*Preliminary Consultation*  
**MONTGOMERY COUNTY HISTORIC PRESERVATION COMMISSION**  
**STAFF REPORT**

<b>Address:</b>	900 Jessup Blair Dr., Takoma Park	<b>Meeting Date:</b>	6/27/18
<b>Resource:</b>	Individually Listed Master Plan Site <b>The Moorings/Jessup Blair House</b>	<b>Report Date:</b>	6/20/18
<b>Applicant:</b>	M-NCPPC	<b>Public Notice:</b>	6/13/18
<b>Review:</b>	Preliminary Consultation	<b>Staff:</b>	Dan Bruechert
<b>Proposal:</b>	Building Rehabilitation

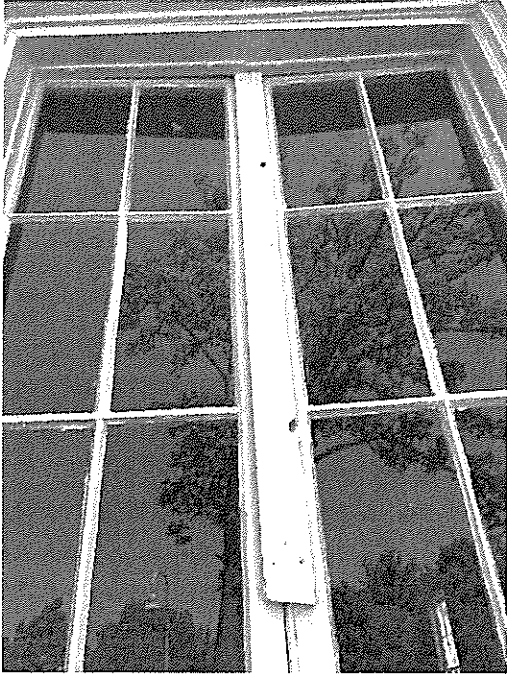
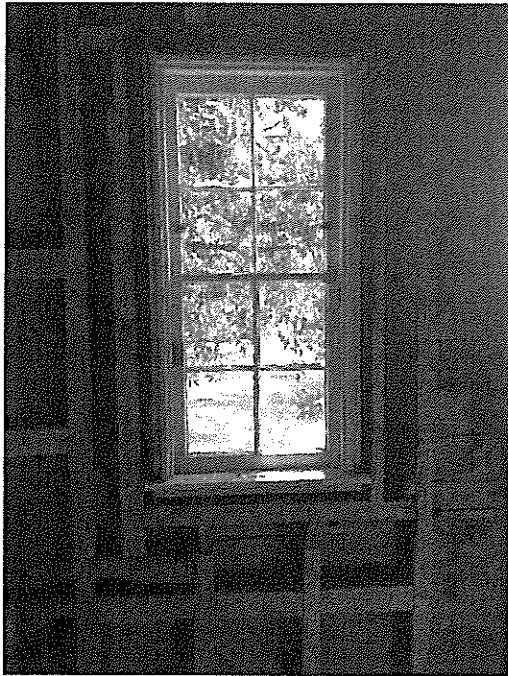
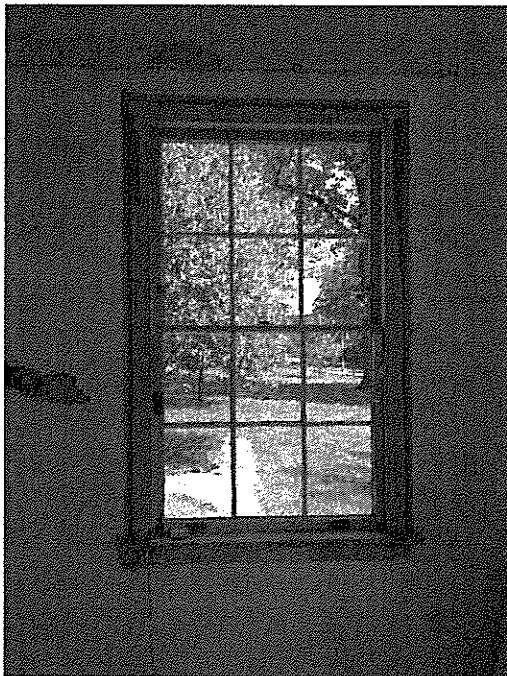
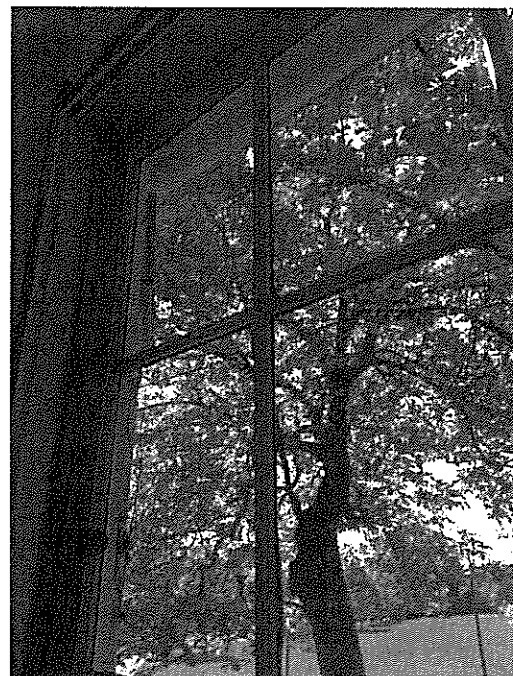
The applicant proposes to remove all of the existing windows in the property and replace them. The applicant identified five general window types in the application and accompanying window survey. There is physical evidence that all of the windows (the paired eight-light casement windows, wooden multi-light sash windows with metal sash cords, multi-light sash windows, single hung sash windows, and twelve-over-twelve sash windows) were installed later than the building's 1850 construction date. The windows in the library likely date to its 1942 construction, however, an exact date for the other windows is challenging to identify. All of the interior trim has been removed and only the windows from the 1942 addition retain their sills (see the attached window survey: Circle \_\_\_\_).

In reviewing the materials presented in the application and observations at a site visit, Staff finds that the windows in the building are not original to the house and have deteriorated beyond repair. The applicant seeks HPC guidance on the appropriateness of a complete window removal and Staff encourages the HPC to detail preferred specifications for replacement windows.

*MNCPPC seeks the HPC's guidance as to whether a complete window replacement would be warranted in this instance, due to the extent of the deterioration of the windows, the difficult challenge of making the windows operable and lead safe, and code issues related to the building's change of use.*

Areaway at side (south) elevation, library ADA entrance at right. Note gas meter and electrical cabinet.

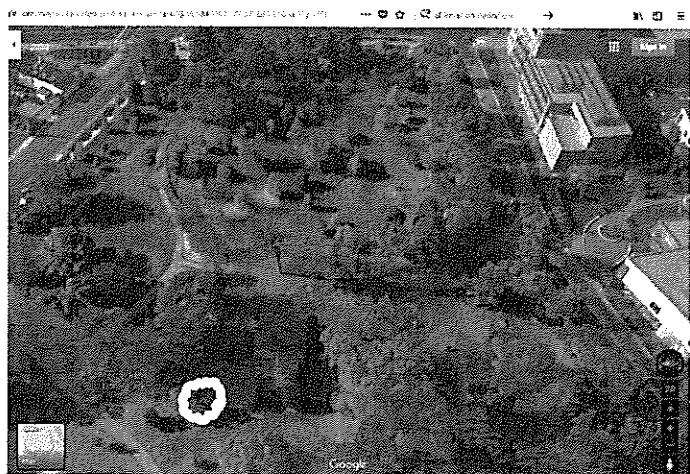
### **Install A Bilco Metal Cover Over Areaway on the South Elevation**

To the west of the ADA ramp is a narrow areaway that provides access to the basement below the historic house. There is a non-historic aluminum railing around this areaway. Access to this space needs to be maintained for proper building maintenance. This proposal will not relocate the existing gas meter.

The applicant proposes to remove the aluminum railing and to install a new bilco-type door. Staff finds that this proposal would de-clutter the appearance around the building by removing a non-historic railing and installing a new door at grade. Staff finds that this proposal will not substantially alter any of the historic features of the house and supports the proposal in concept.

The applicant seeks HPC guidance on the appropriateness of this solution as rehabilitation plans are further developed.

*MNCPPC seeks confirmation that a metal areaway cover of some sort is consistent with the HPC's criteria for approval.*

**Photograph 9**  
**Porch, Stairway & Ramp at Library Connector & Library Wing Entrance**

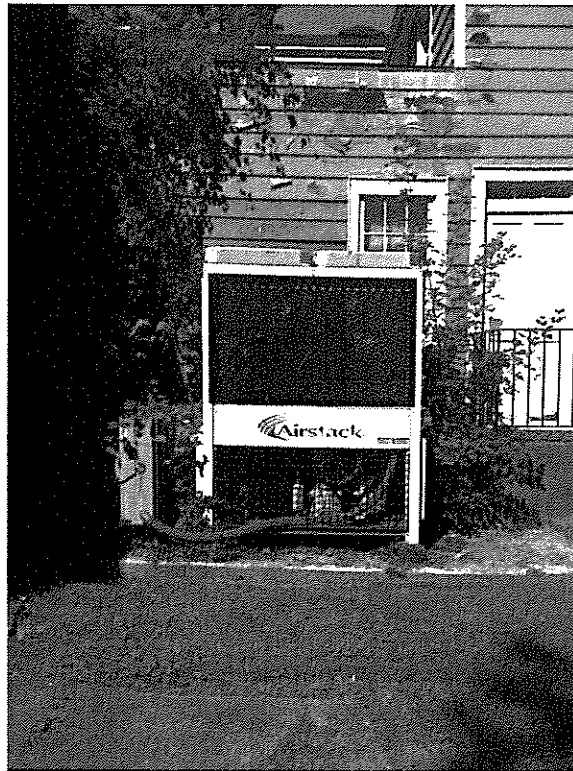
**Remove the Existing ADA Ramp and Replace it with a Reconfigured Ramp**

The existing ADA ramp is located between the historic house massing and the library wing. It is constructed out of brick and poured concrete with an aluminum railing and does not meet current building codes. The existing ramp and railing also eliminate access to non-historic brick steps.

The applicant proposes to install a new code-compliant ramp and stairs that will be installed to provide access to the same entrance. The run of the proposed ramp extends to the south in front of the library wing before a 180° turn north to the door. Materials in the renderings show the ramp will have face brick and a pipe metal railing. To accommodate the reconfigured ramp, the swing of the door will have to be reversed.

Staff finds that while the proposed ramp will obscure more of the library wing than the existing ramp configuration, the proposal will create a safer, more usable entrance without detracting from the more highly decorated front elevation. Additionally, as the library space is to be community oriented, direct access to this space is significant to the proposed building operation. Staff further finds that changing the door swing will not detract from the historic character of the building and supports its approval.

The applicant seeks HPC guidance on the appropriateness of this design solution.

*MNCPPC seeks the HPC's affirmation that proposed accessible entrance, including reversing the door swing, is consistent with the HPC's criteria for approval.*

Currently a window; proposed for replacement with door for egress

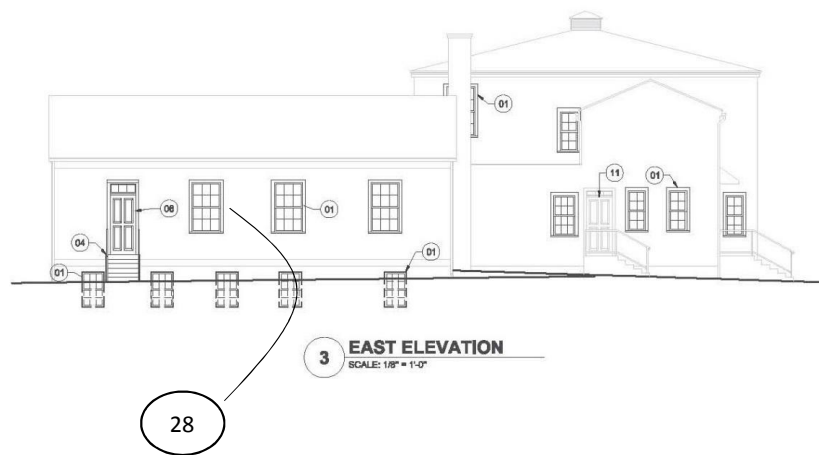
### **Convert a Window on the Rear into a Door**

The library wing to the southwest of the main house requires a secondary means of egress for occupancy. The applicant proposes converting a window on the east (rear) elevation of the library into a door. The door will be accessed by a new wooden set of stairs and landing.

The plans show a four-panel door with a transom above. It appears as though the window head height will match the transom head. Staff finds that this will create a more unified appearance that is compatible with the historic appearance. Staff further finds that the proposed location will in the southeast corner will have the least visual impact on the building's features.

The applicant seeks HPC guidance on the appropriates of creating a secondary means of egress in this location.

*MNCPPC seeks the HPC's guidance on the proposal to convert this window to a door in order to meet secondary egress requirements related to the building's change of use.*
